UNITED STATES PATENT AND TRADEMARK OFFICE

APPLICATION NO.	FILING DATE	FIRST NAMED INVENTOR	ATTORNEY DOCKET NO.	CONFIRMATION NO.
09/961,114	09/20/2001	Donald V. Perino	RB1-035USC3	4507
29150	7590	07/14/2004	EXAMINER	
LEE & HAYES, PLLC 421 W. RIVERSIDE AVE, STE 500 SPOKANE, WA 99201			FIGUEROA, FELIX O	
			ART UNIT	PAPER NUMBER
			2833

Office Action Summary

DETAILED ACTION

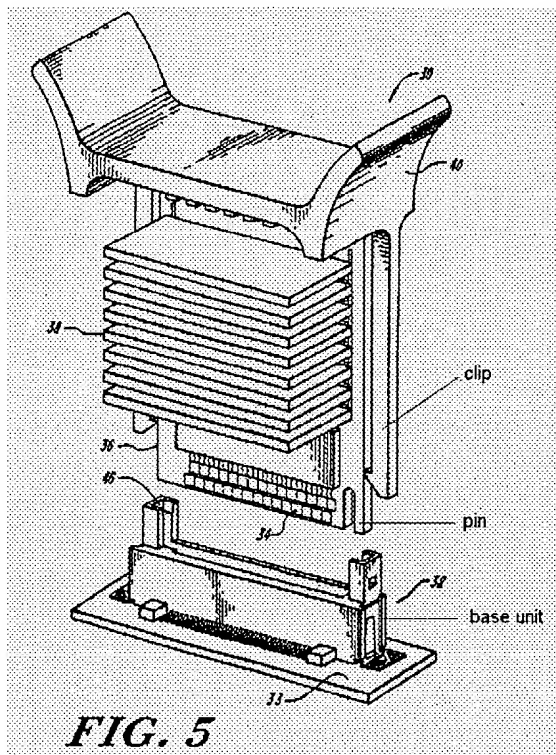
Bellomo discloses a chip socket assembly comprising: a single chip package (36) configured to house a single integrated circuit chip; a first clip arm extending from a first side of the chip package; a second clip arm extending from a second side of the chip package, the first side and the second side being opposite one another; and leads (34) connected to a third side of the chip package. See the following Figure.

Regarding claim 99, Bellomo discloses the first clip arm and the second clip arm each include a ledge protruding from their ends, the chip socket assembly further comprising: a base (32) for receiving the chip package and facilitating the mechanical and electrical connection between the single integrated circuit chip and the circuit board (33), the base having a first socket and a second socket (at 46) for securing the chip package to the base, the first socket configured to receive the ledge of the first clip arm and the second socket configured to receive the ledge of the second clip arm.

Regarding claim 111, Bellomo discloses a pin (see previously shown Figure) extending from the chip package; and a slotted guide in the base configured to receive the pin and guide the chip package into the base.
